TSG-RAN Working Group 1(Radio) meeting #5 **TSGR1#5(99)605**
Cheju, Korea, 01 – 04 June 1999

Source: **Editor**

Title: Proposed changes to TS 25.201 V2.0.0

Fig. 5-1 Radio interface protocol architecture around the physical layer

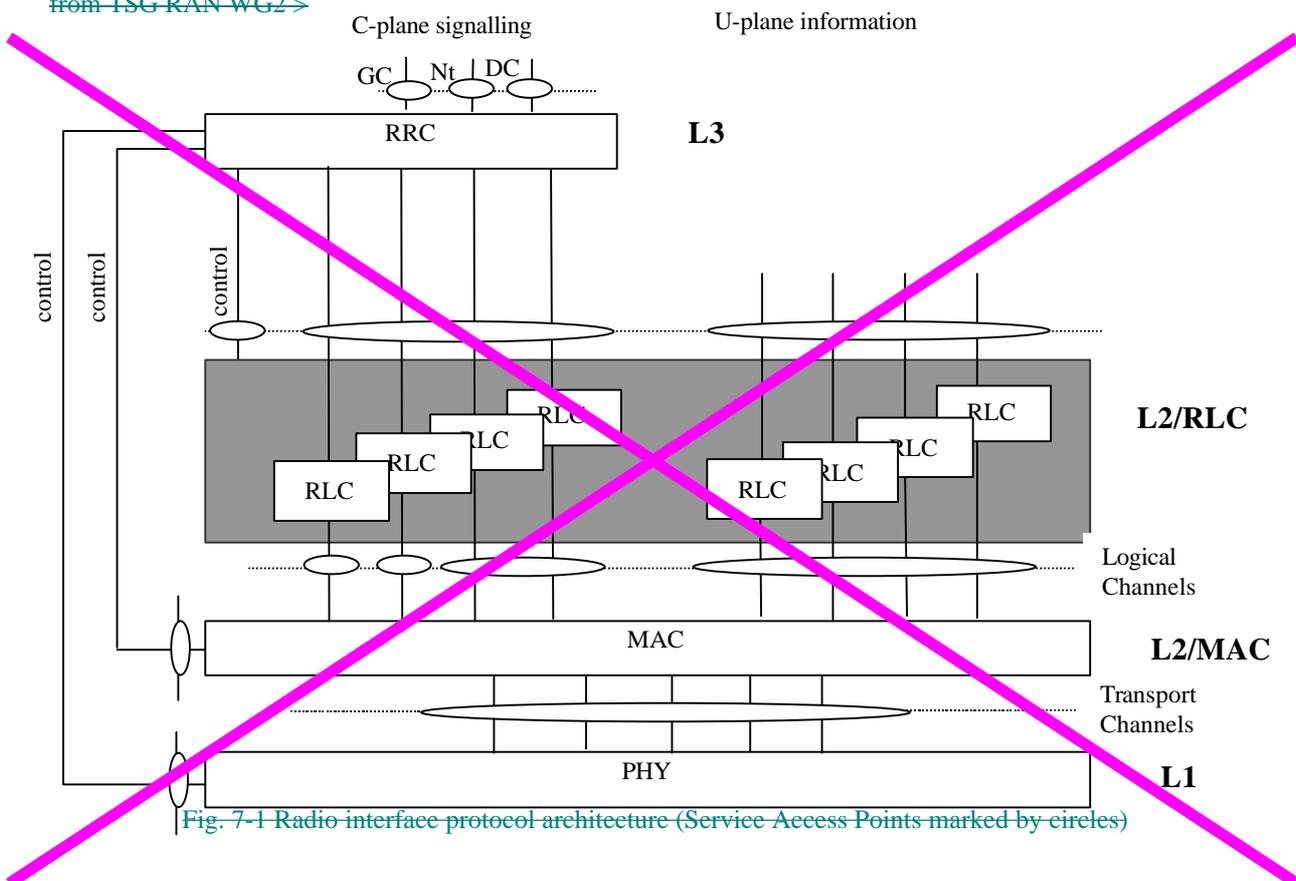
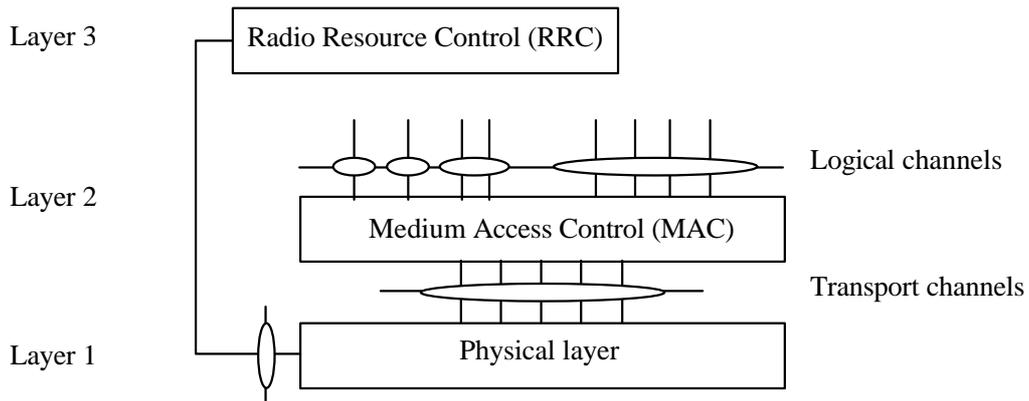
2) Figure 7-5 protocol architecture was copied from S2.01 V1.0.0 (currently TS 25.301). This figure contains a little bit detail as included in TS 25.201. I propose using a simplified figure. The proposed modification is attached below.

~~<Editor's Note: The following figure comes from S2.01 V0.0.1. The figure needs update to be aligned with S2.02 from TSG RAN WG2 >~~

Figure 74-1 shows the UTRA radio interface protocol architecture around the physical layer. The physical layer interfaces the Medium Access Control (MAC) sub-layer of Layer 2 and the Radio Resource Control (RRC) Layer of Layer 3. The circles between different layer/sub-layers indicate Service Access Points (SAPs). The physical layer (Layer 1) offers different Transport channels to L2/MAC. A transport channel is characterized by how the information is transferred over the radio interface. L2/MAC offers different Logical channels to the Radio Link Control (L2/RLC) sub-layer of Layer 2. A logical channel is characterized by the type of information transferred. Physical channels are defined in the physical layer. There are two duplex modes: Frequency Division Duplex (FDD) and Time Division Duplex (TDD). In the FDD mode a physical channel is characterized by the code, frequency and in the reverse link the relative phase (I/Q). In the TDD mode the physical channels is also characterized by the timeslot. RRC controls RLC, MAC andThe Physical physical layer is controlled by RRCvia primitives.
